# AGENDA

December 18, 2012

2. **Pine Valley Mill Commerce Center & Residences at the Mill – Dakota Partners, et al – Wilton Rd – Map 6, Lot 13;** Public Hearing for a proposed two (2) unit condominium conversion.
   *(Fieldstone Land Consultants, PLLC)*

3. **C. Fuel Management, LLC – Hollow Oak Ln – Map 7, Lot 5-5;** Public Hearing for a proposed site plan amendment to add two (2) 30,000 gallon propane tanks.
   *(Sanford Survey & Engineering)*

PRELIMINARY COMMERCIAL SITE PLAN
# CIARDELLI FUEL COMPANY, Inc.
*TAX LOT MAP 7 LOT 5-5*
*HOLLOW OAK LANE*
*MILFORD, NEW HAMPSHIRE*

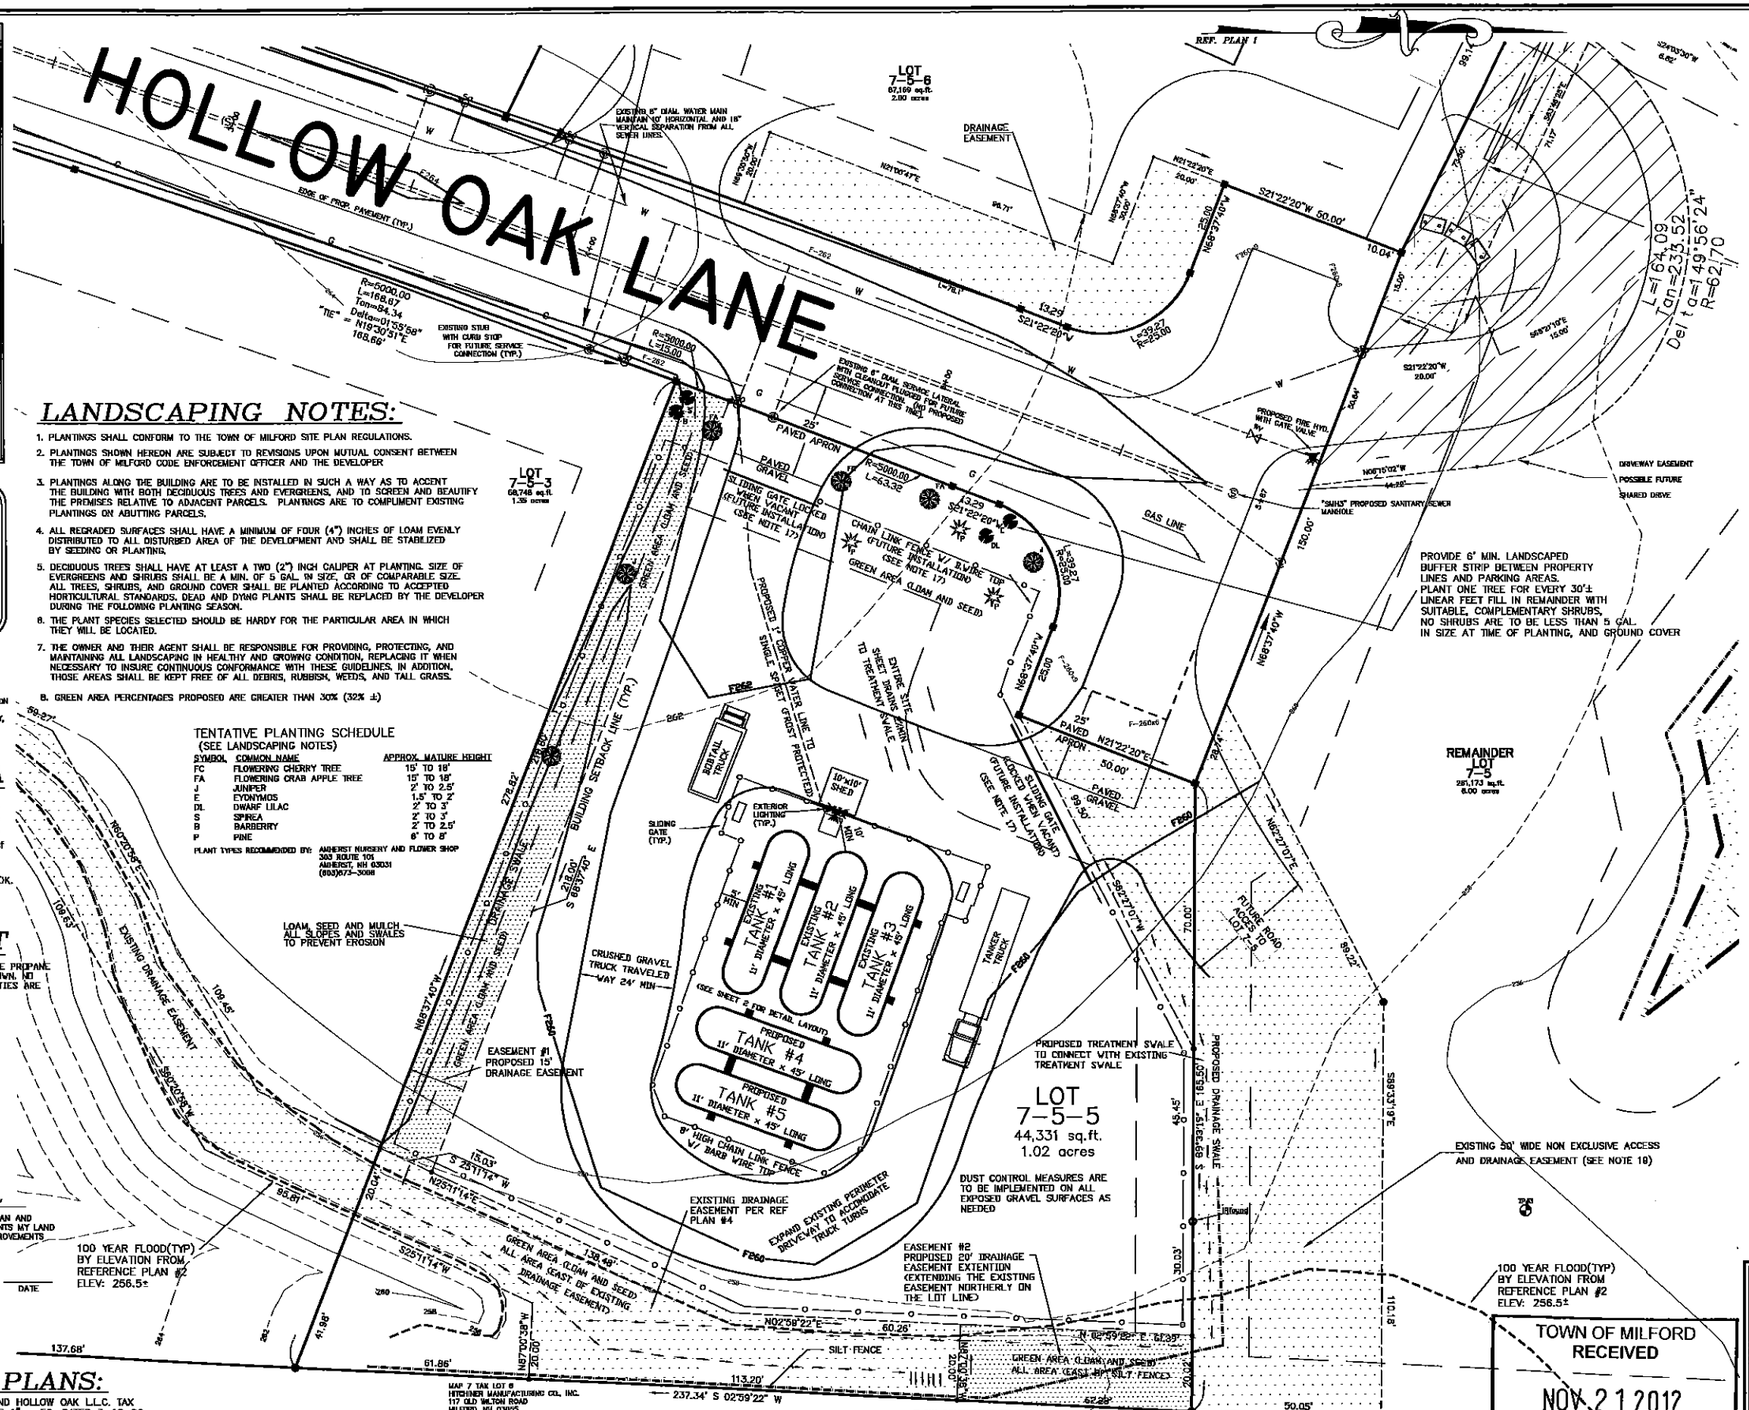
**Interdepartmental Reviews:**
Environmental Coordinator – It does not appear that the proposed amendment significantly alters the site drainage. However, it would be beneficial for the engineers to confirm this – perhaps as a plan note.

1. Change all occurrences of the use of "proposed drainage easement", "proposed drainage swale" and "proposed treatment swale" to existing.
2. A note be added to the plan stating the proposed additional propane storage tanks shall not alter the site drainage.
3. Update revision dates on plan.
4. If an additional sliding gate is proposed in the area of new tanks it shall be updated on the plan.

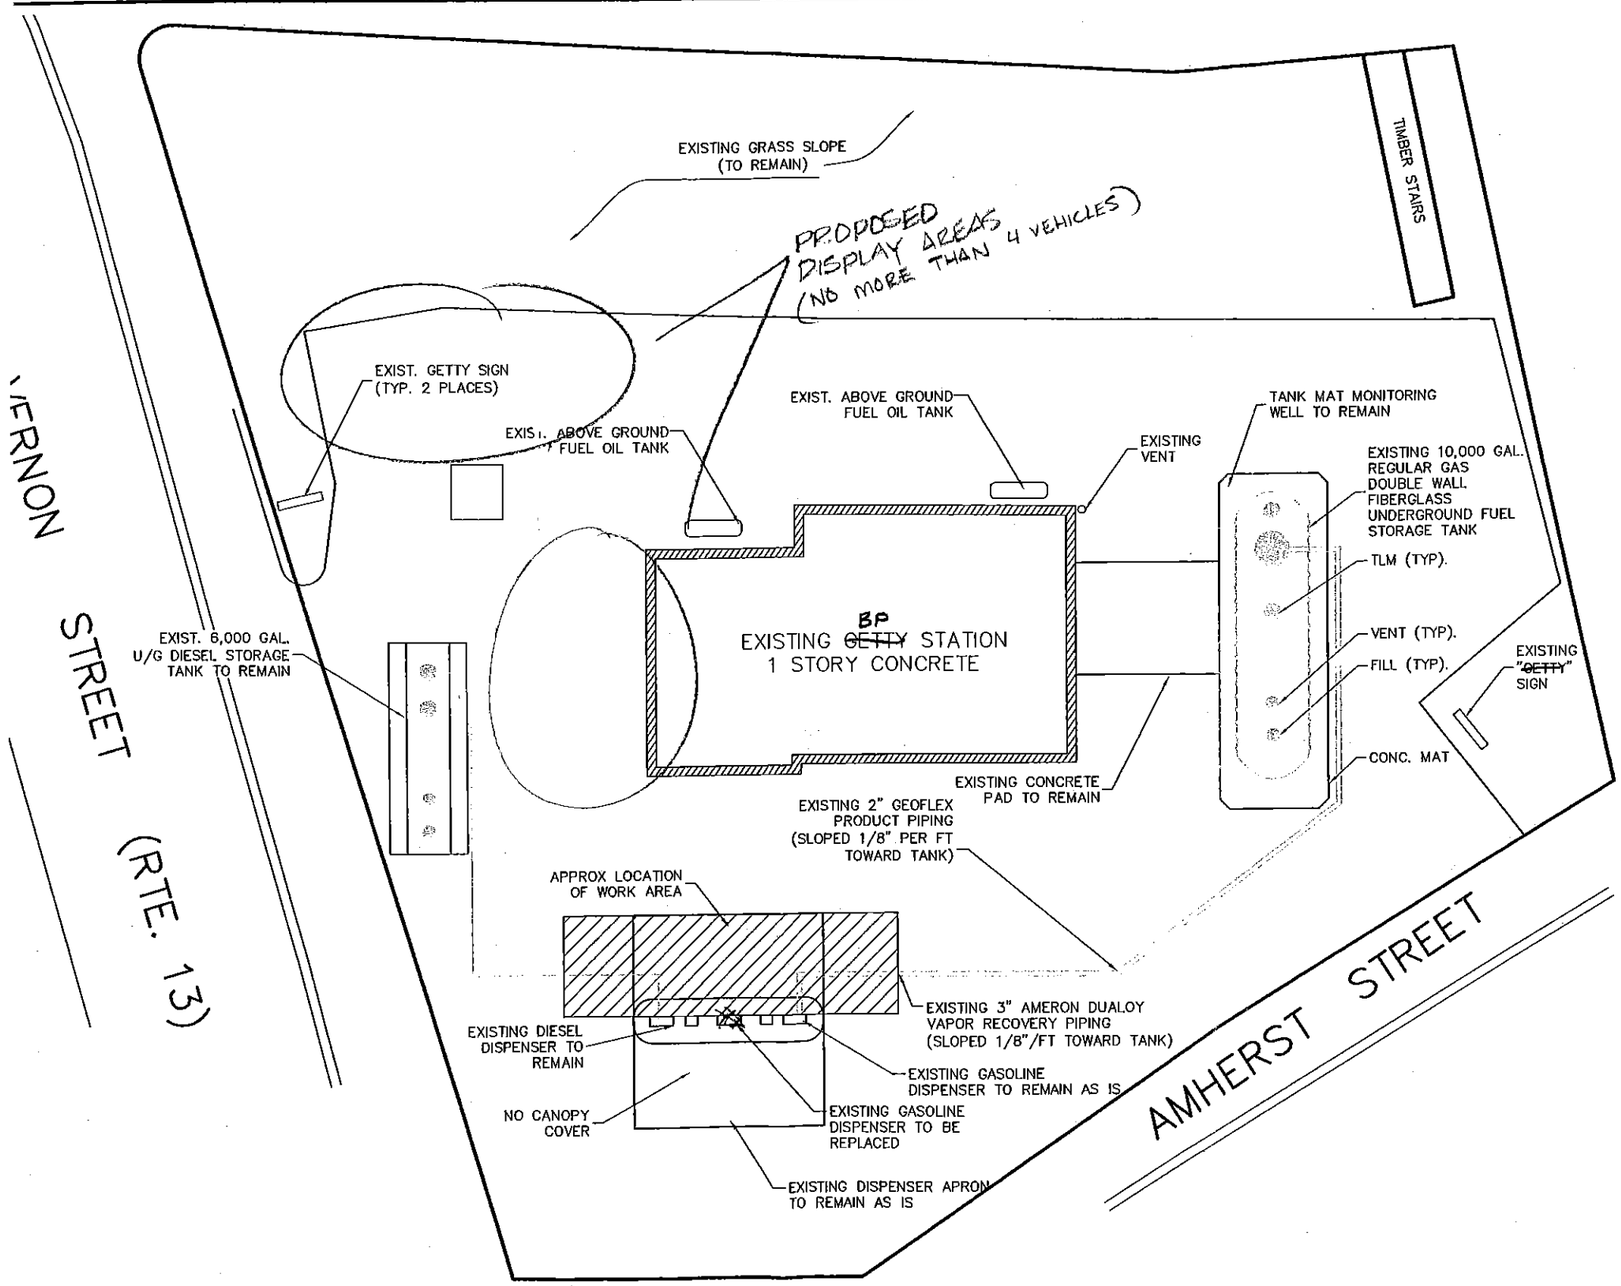
Code Enforcement/Building – I would just make sure the Planning Board verifies there is enough space for 4 vehicles in the current location, In the past there has only been 1 vehicle for sale at a time at that location and it seems a little small for 4.
